TOWN OF NEWBURGH
PLANNING BOARD
TECHNICAL REVIEW COMMENTS

PROJECT:	**MAVIS TIRE/MIXED USE (RHINEBECK REALTY LLC)**
PROJECT NO.:	**15-03**
PROJECT LOCATION:	**SECTION 60, BLOCK 3, LOT 40.2**
REVIEW DATE:	**29 APRIL 2016**
MEETING DATE:	**5 MAY 2016**
REPRESENTATIVE:	**BOHLER ENGINEERING**

SHEET TITLE: SITE PLAN

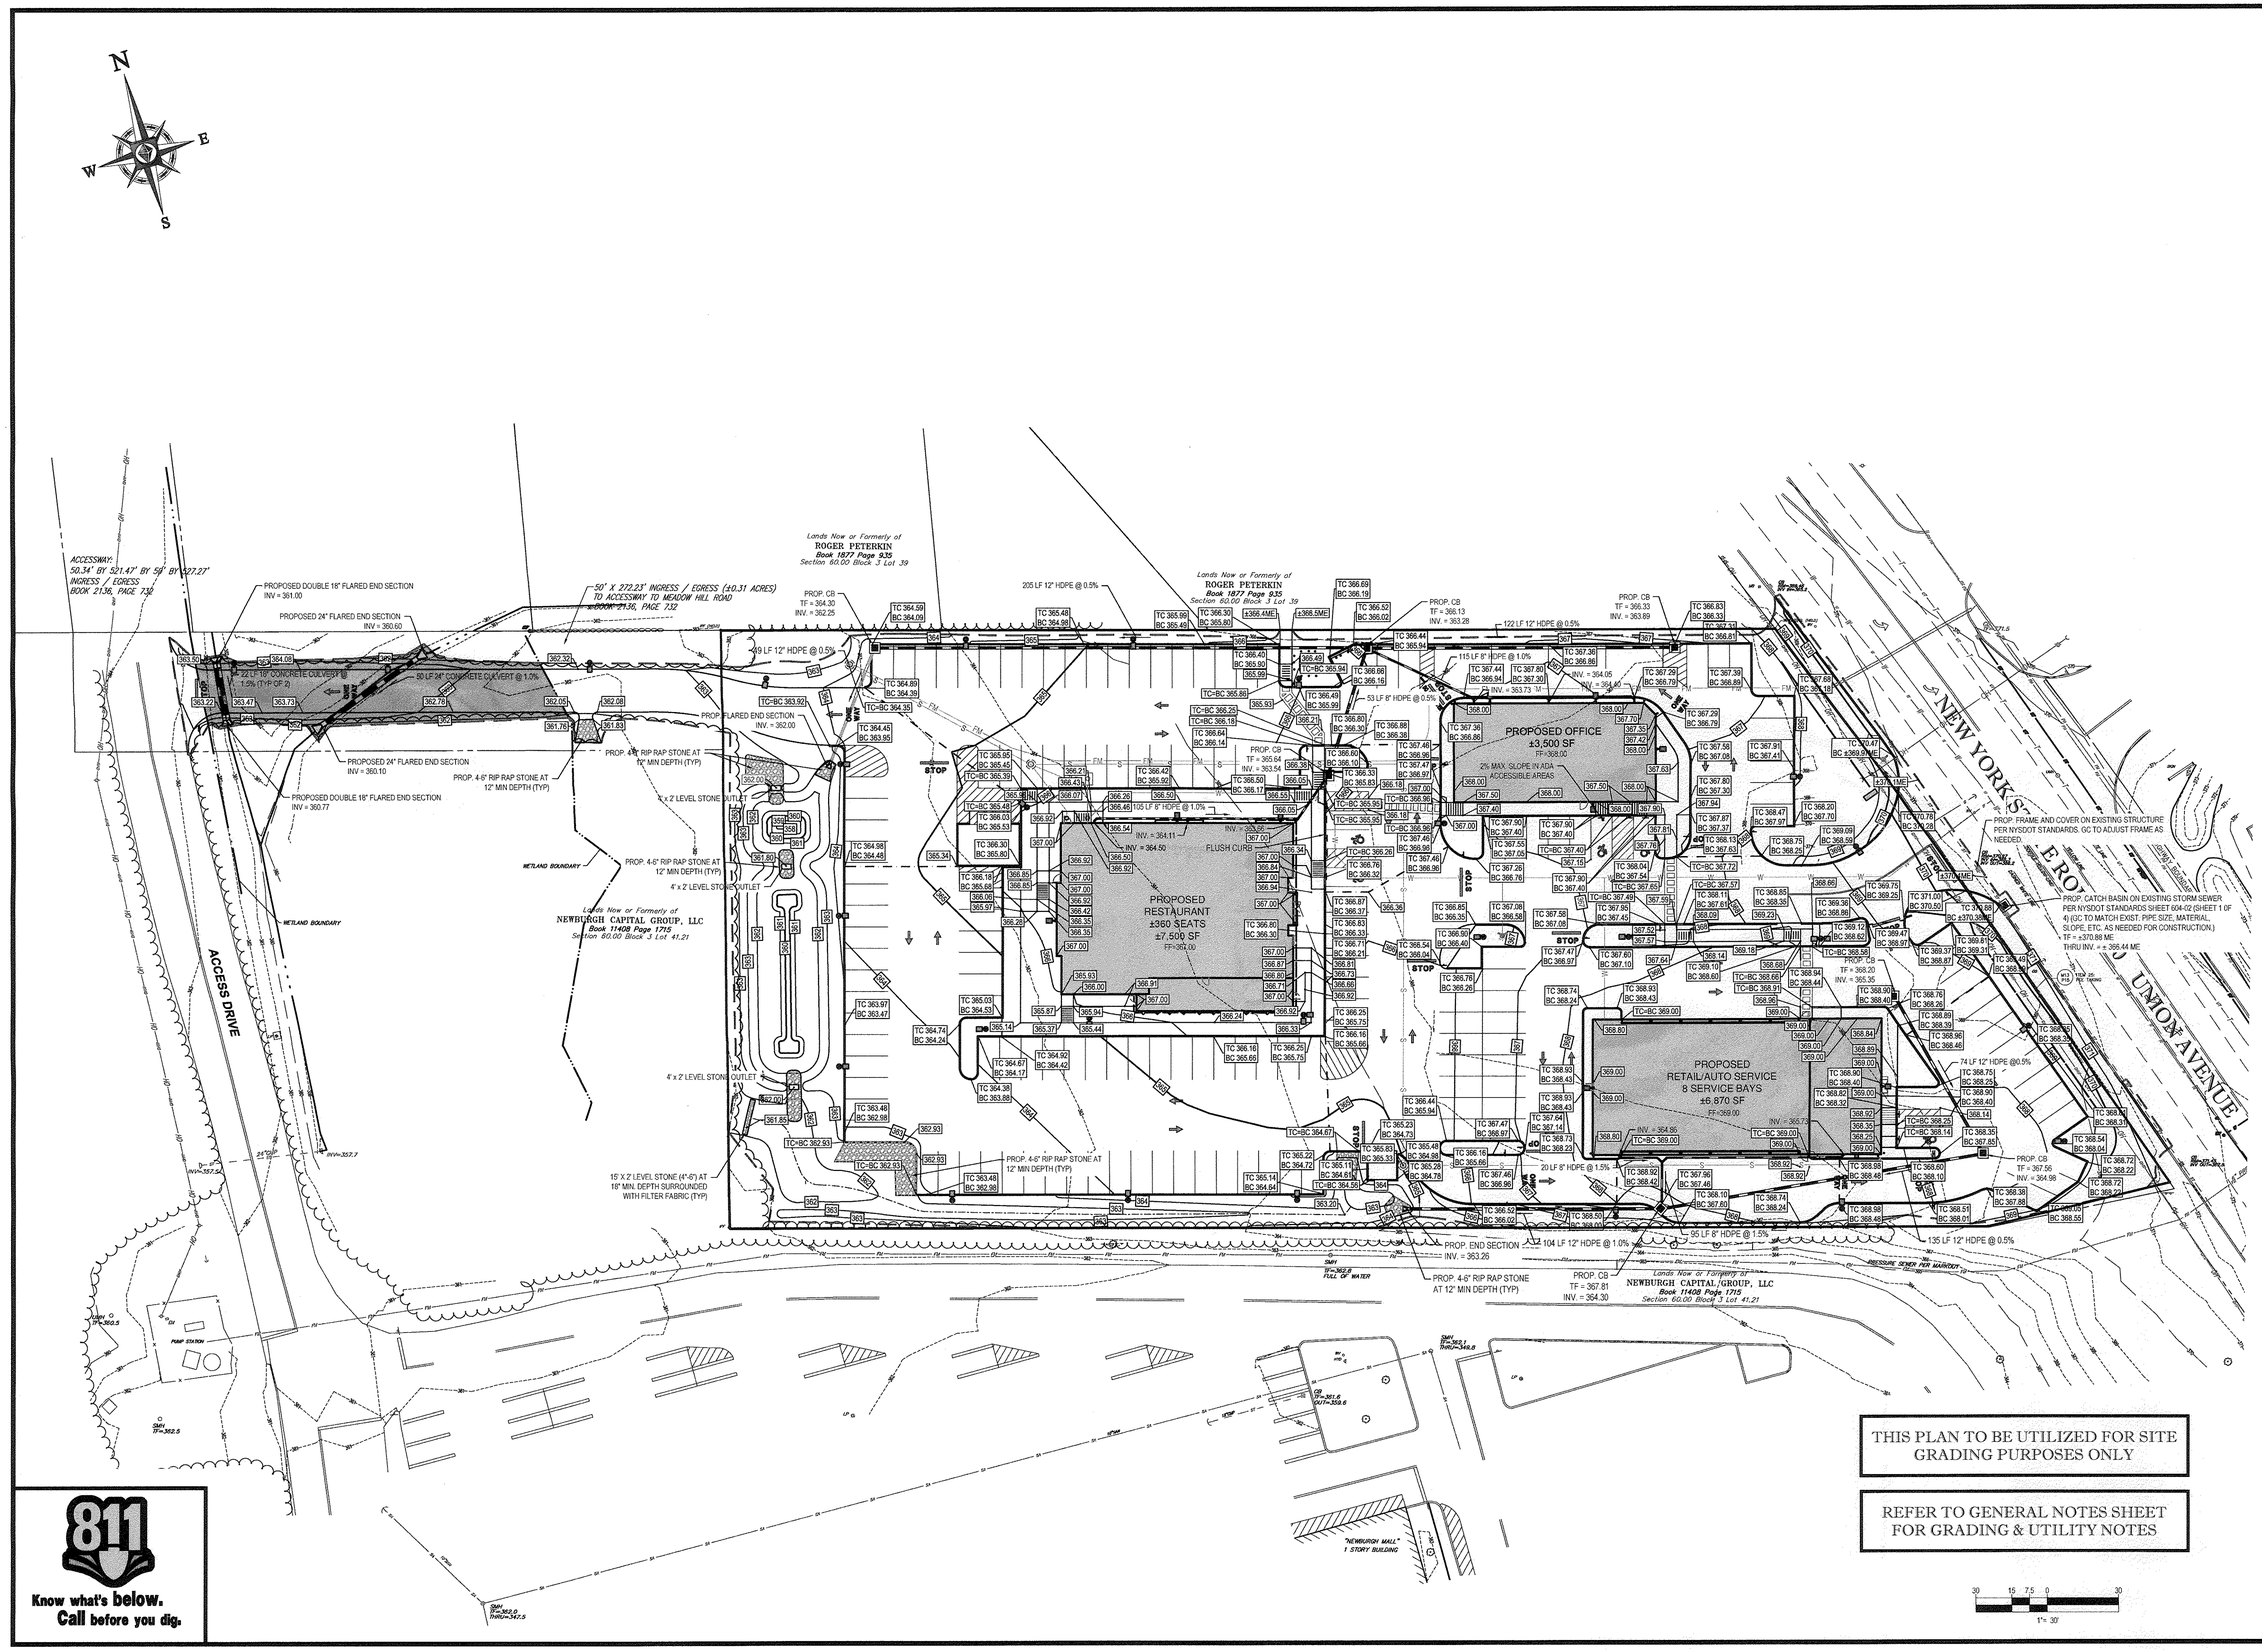
2. Building footprints have been slightly modified. Based on the location of the buildings at the front and side yard setbacks it is recommended that a note be added to the plans that a surveyed plot plan be provided to the Building Inspector's Office prior to issuance of a building permit in order to avoid any zoning issues with the building construction of the office and service building.

4. The access drive has been revised per NYSDOT comments. Information pertaining to the NYSDOT approval of the access drive should be submitted for the Boards use.

14. 20 foot high light poles are identified on the site plan. These appear appropriate based on the scale of the project.

15. Planning Board should discuss landscaping at the property frontage. Previous discussions involved berms and/or stone walls which appear to have been removed from the plans.

UTILITY PLAN

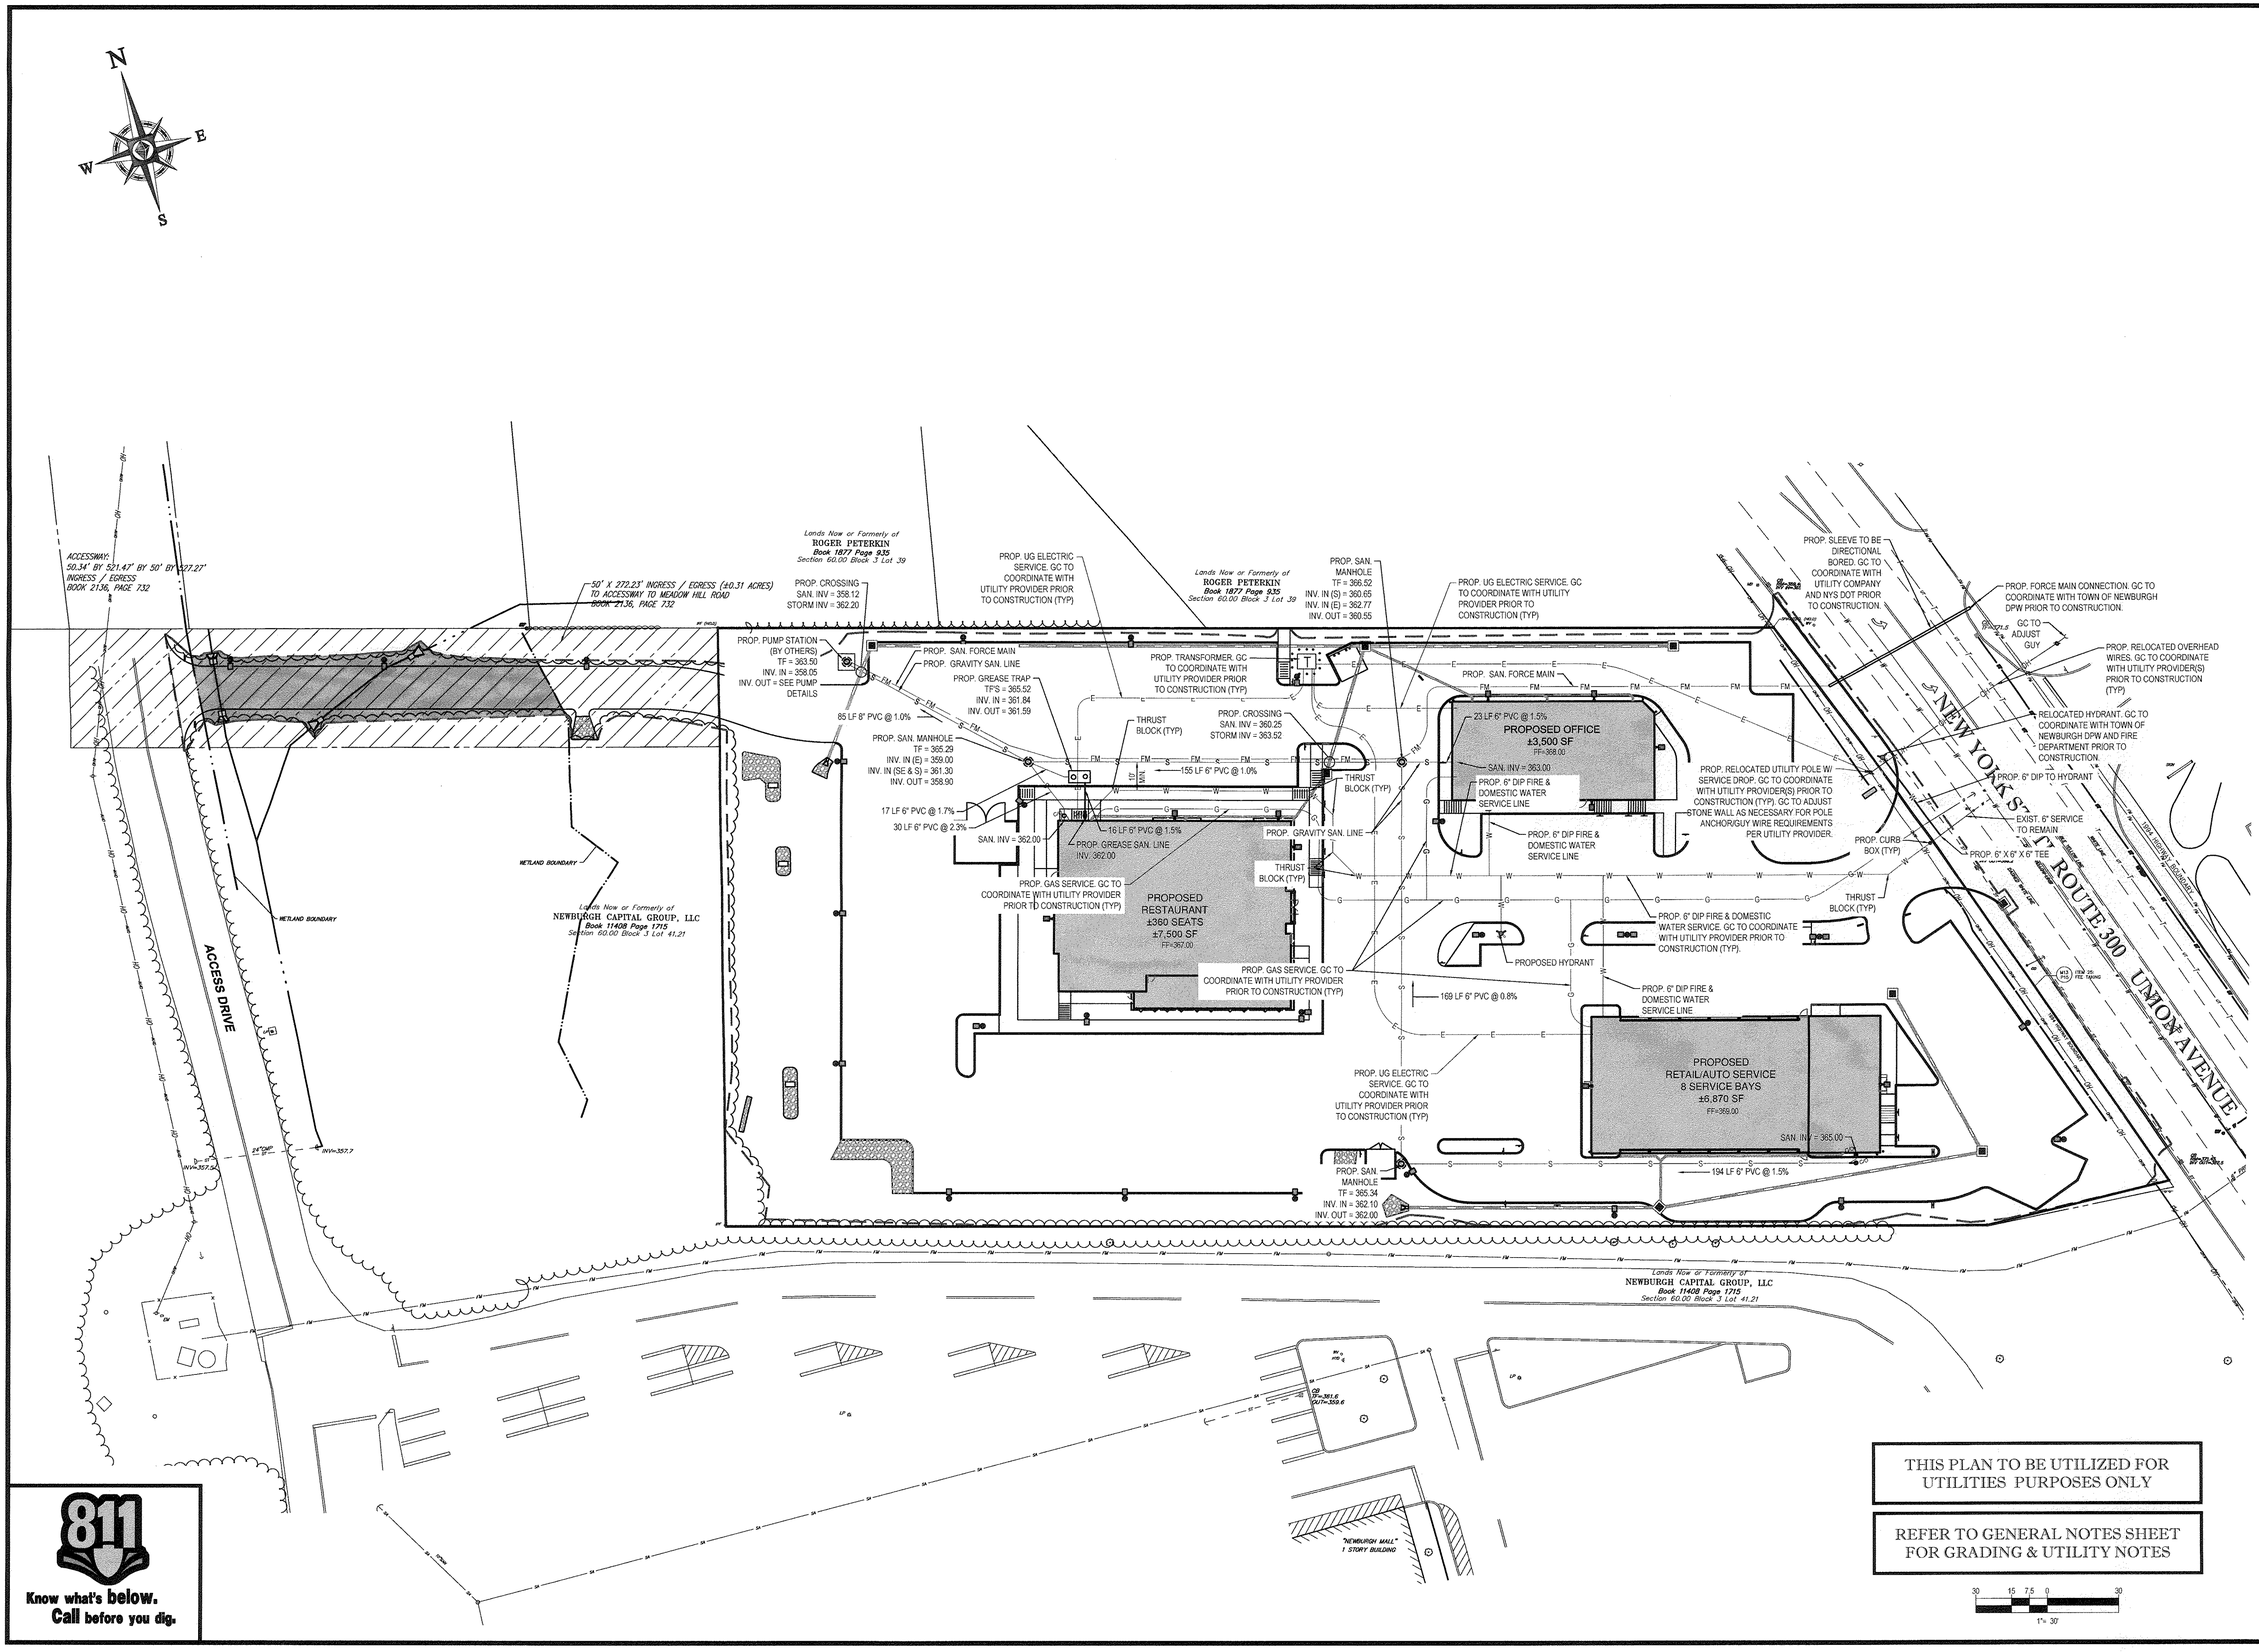
5. Plans continue to contain thrust box for the water lines. Town of Newburgh requires restraint joint pipes. Restraint joint pipe schedule should be provided with thrust box removed from the plan sheets and details.

6. Water lines have been revised to utilize existing service stub to property. Adequate flow for fire suppression system must be documented to code enforcement based on 6 inch mains identified. Health Department approval of the water service with hydrants is required. Modifications to the water lines have been incorporated into the plans utilizing existing 6 inch stub to property line. Adequate water supply for fire suppression systems must be documented to code enforcement prior to Building permit. Orange County Health Department approval of the water system is required due to the presence of hydrants. Backflow prevention devices will be required.

11. Proposed electric system to the restaurant appears to cross over a grease trap. This should be revised.

12. Details of forced main clean out should be provided. It is recommended a forced main clean out be provided as currently as none is shown.
